**Bid Bulletin No. 2**  
**MODIFICATIONS IN THE INVITATION TO BID AND**  
**PLANS/ DRAWINGS**

This Supplemental/ Bid Bulletin no. 1 dated December 13, 2021 for the project **"NEGOTIATED PROCUREMENT MODERN SCIENCE LABORATORY AT MENESES CAMPUS (Infra-2021-15)"**, is issued to modify or amend the items in the Bid Documents. Accordingly, this shall form an integral part of said Documents

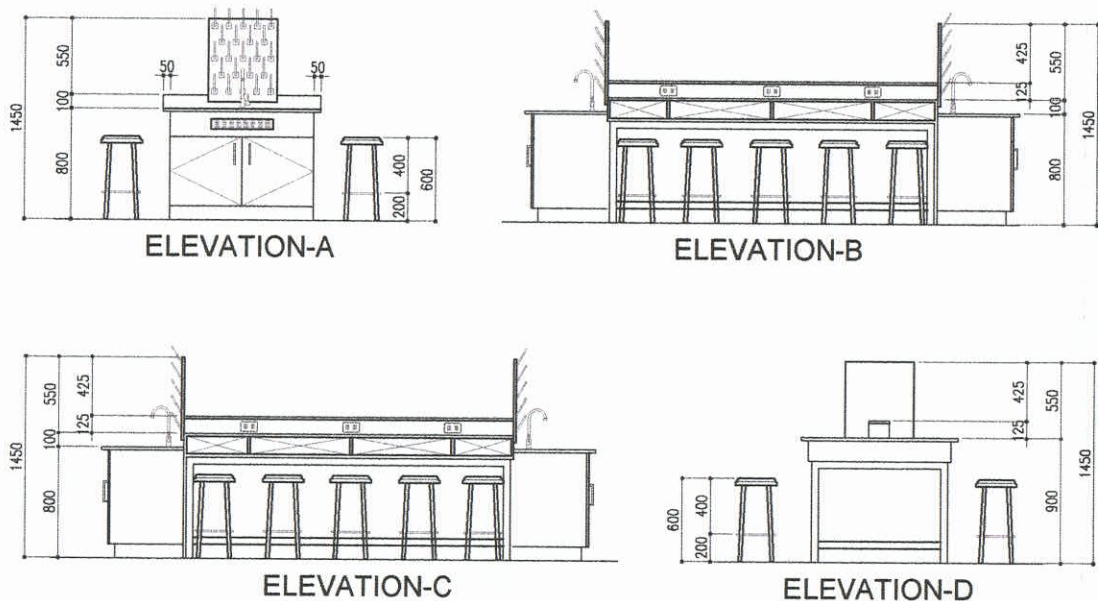
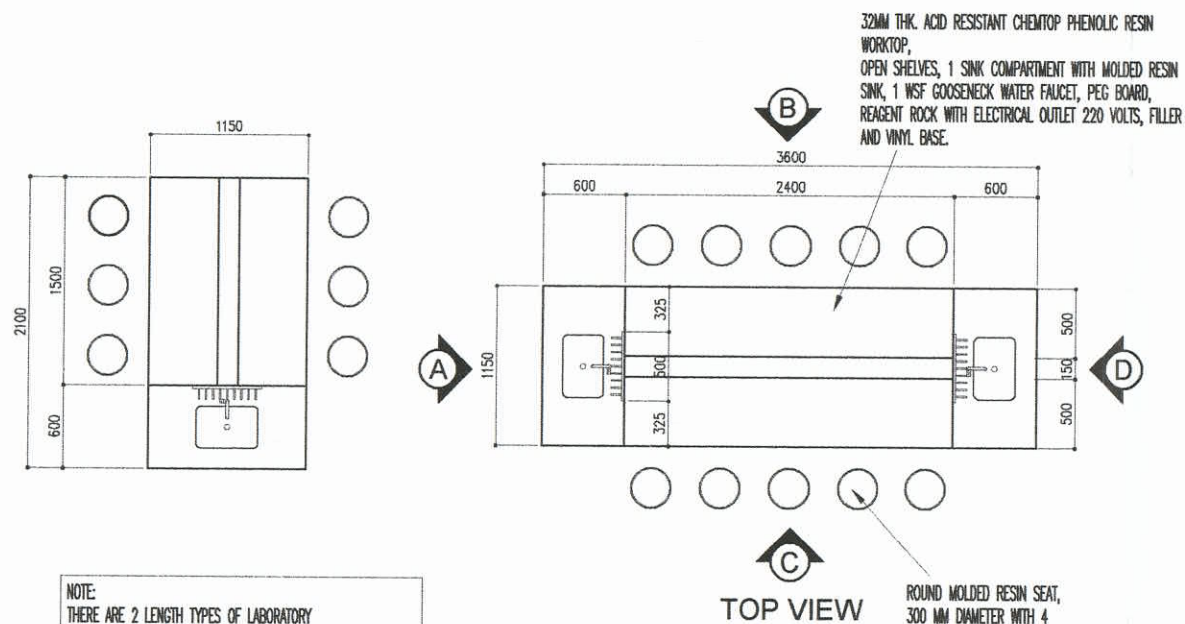
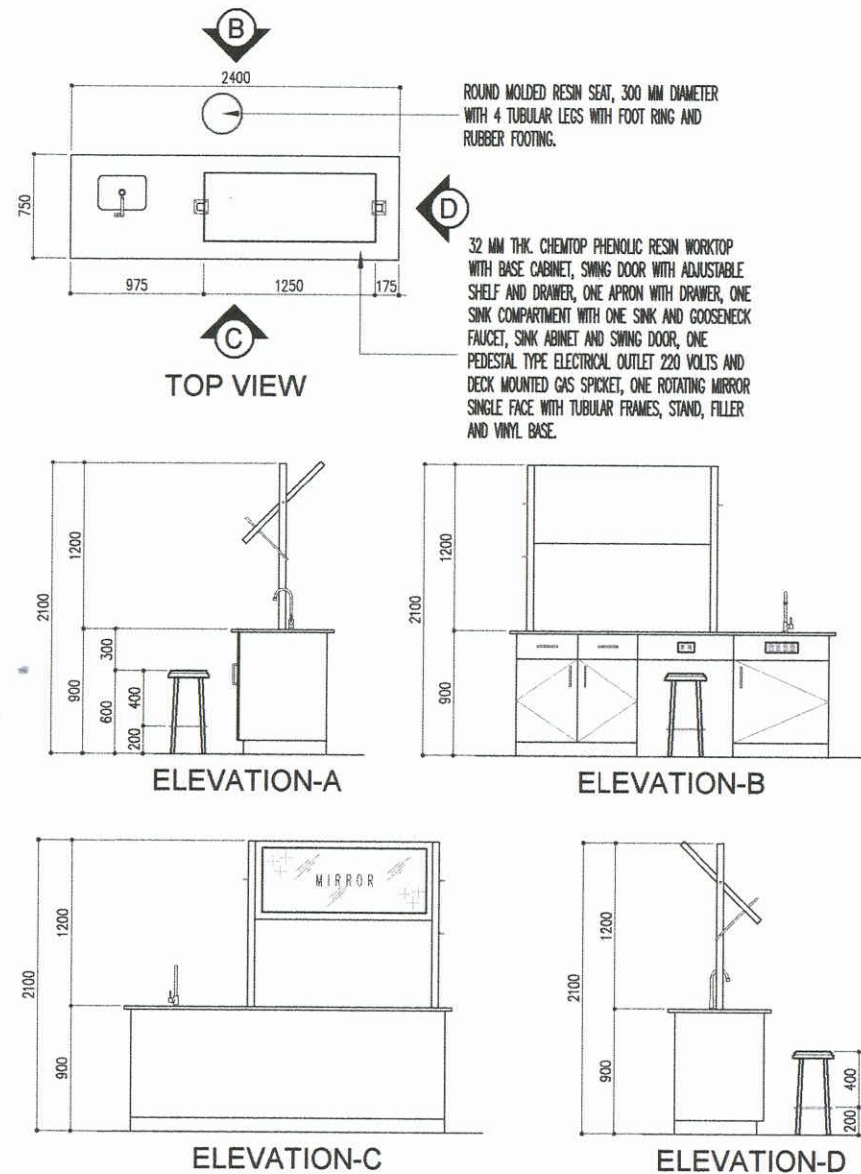
<b>FROM</b>	<b>TO</b>
Plans/ Drawings		<u><b>Additional Entry:</b></u>  <u><b>Please see attached</b></u> <u><b>Sheet no. A-04 and A-09</b></u>

**NOTES:**  
ALL LABORATORY CENTRE TABLE AND DEMO TABLE SHOWS IN THESE DRAWING IS NOT INCLUDED IN THE SCOPE OF WORK. THIS WILL BE SUPPLIED BY OTHER.
